Issues and Concerns with Aurizon Network's (AN's) 2013 Draft Amending Undertaking (DAU)

Forecast and Actual Tonnages from UT2 to UT4

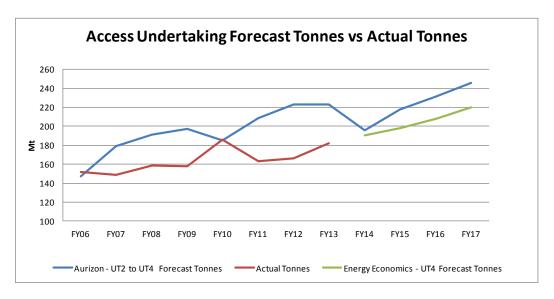
The DAU forecasts 910.4 million tonnes will be moved in the 4 year regulatory period, compared to 698.1 million tonnes moved in UT3's 4 year regulatory period. There has been consistent overstatement of forecast system tonnages in the previous two access undertakings. Whilst we understand the 910.4 million tonnes represents approximately 75% of contracted volumes, we remain concerned such volumes are still quite bullish given the current global coal market environment. Whilst we endorsed the FY14 volumes used in the Authority's interim tariff decision, the GAPE volumes were considered separately and based on railings to date, look like being overly optimistic for FY14. Similarly, delays in our Hay Point Terminal expansion project (HPX3) reveal that our terminal will not reach a 55 million tonnes annual capacity rating until calendar year 2015.

Energy Economics⁵ independent forecast of coal railings during the UT4 period, identify a total railings forecast of 816Mt from FY14 to FY17, compared with Aurizon Network's forecast of 910Mt.

We recommend the Authority adopt the Energy Economics UT4 tonnage forecast as more representative of current conditions and growth projects being progressed within the UT4 timeframe. It is noted that Energy Economics total UT4 coal railing forecast of 816.3Mt is actually less than Aurizon's UT3 railing forecast of 841Mt. However, given our experience with both GAPE railings and an export coal terminal expansion, we recommend the Authority err on the side of caution in terms of the demand forecasts in UT4.
